# Current ENERGY STAR Certified Homes Policy Record

## ENERGY STAR Certified Homes Policy Record

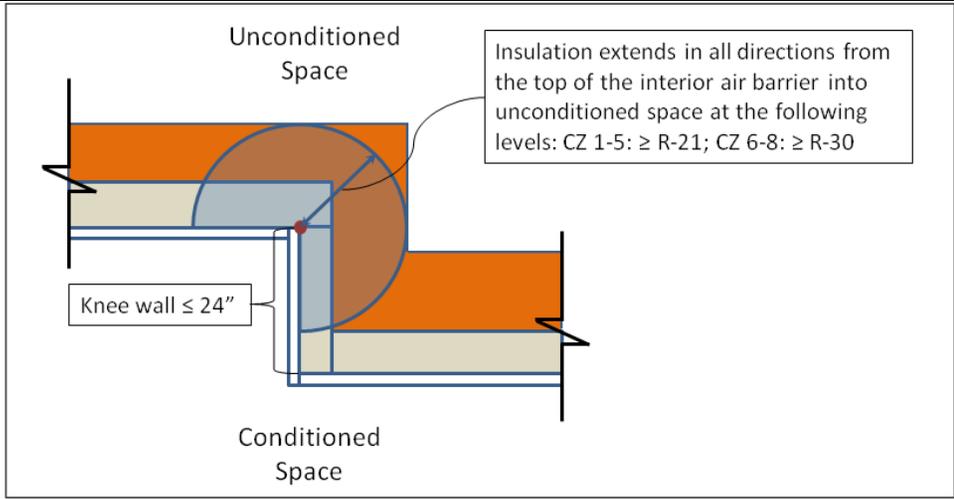
00112	06/01/2013	Thermal Enclosure System Rater Checklist (Version 3, Rev. 06)	Change	<b>Item 3.1.3 - Exemption from exterior air barrier for certain short attic knee walls</b>
				<p><b>Issue:</b> Partners have asked if the requirement for an exterior air barrier at attic knee walls applies to attic knee walls that are buried in attic floor insulation. Such attic knee walls may be present at small changes in ceiling height such as tray ceilings and soffits.</p>
				<p><b>Resolution:</b> Exterior air barriers are generally needed in attic knee walls to support the knee wall cavity insulation and to prevent convection and wind washing. However, in short attic knee walls that are supported by adjacent attic insulation, these needs are minimized.</p> <p>Therefore, an exterior air barrier is not required for attic knee walls that are less than or equal to 24 inches in height if an interior air barrier is provided and insulation extends in all directions from the top of this interior air barrier into unconditioned space at the following levels: CZ 1-5: <math>\geq R-21</math>; CZ 6-8: <math>\geq R-30</math>. This policy is illustrated in the exhibit below:</p>

<p data-bbox="877 727 1999 880">To reflect these changes, a new Footnote will be added to Item 3.1.3 to provide this exemption. It will read as follows:          “Exterior air barriers are not required for attic knee walls that are ≤ 24 in. in height if an interior air barrier is provided and insulation extends in all directions from the top of this interior air barrier into unconditioned space at the following levels: CZ 1-5: ≥ R-21; CZ 6-8: ≥ R-30.”</p>
00283	12/31/2012	Thermal Enclosure System Rater Checklist (Version 3, Rev. 06)	Change	<p data-bbox="877 896 1999 938"><b>Item 4.2 - Slab edge insulation alternative for existing homes</b></p> <p data-bbox="877 945 1999 1107"><b>Issue:</b> Partners certifying existing homes have expressed concern that this requirement would require excavation around, or removal of, the slab, which is not typically within the scope even for a gut rehabilitation. If the slab edge is not already insulated, the perimeter around the slab would need to be excavated or the slab itself removed and replaced to add the required insulation.</p> <p data-bbox="877 1114 1999 1243"><b>Resolution:</b> Uninsulated sections of slabs create thermal bridges that reduce the efficiency of the thermal enclosure system and can impact the comfort of the home. Insulating 100% of the slab edge eliminates these thermal bridges. To meet this same intent, rigid insulation ≥ R-3 is permitted to be installed on top of an existing slab prior to the installation of the flooring.</p> <p data-bbox="877 1250 1999 1399">To reflect this alternative, the following will be added to the end of Footnote 4:          “Alternatively, the thermal break is permitted to be created using ≥ R-3 rigid insulation on top of an existing slab (e.g., in a home undergoing a gut rehabilitation). In such cases, up to 10% of the slab surface is permitted to not be insulated (e.g., for sleepers, for sill plates). Insulation installed on top of slab shall be covered by a durable floor surface (e.g., hardwood, tile,</p>
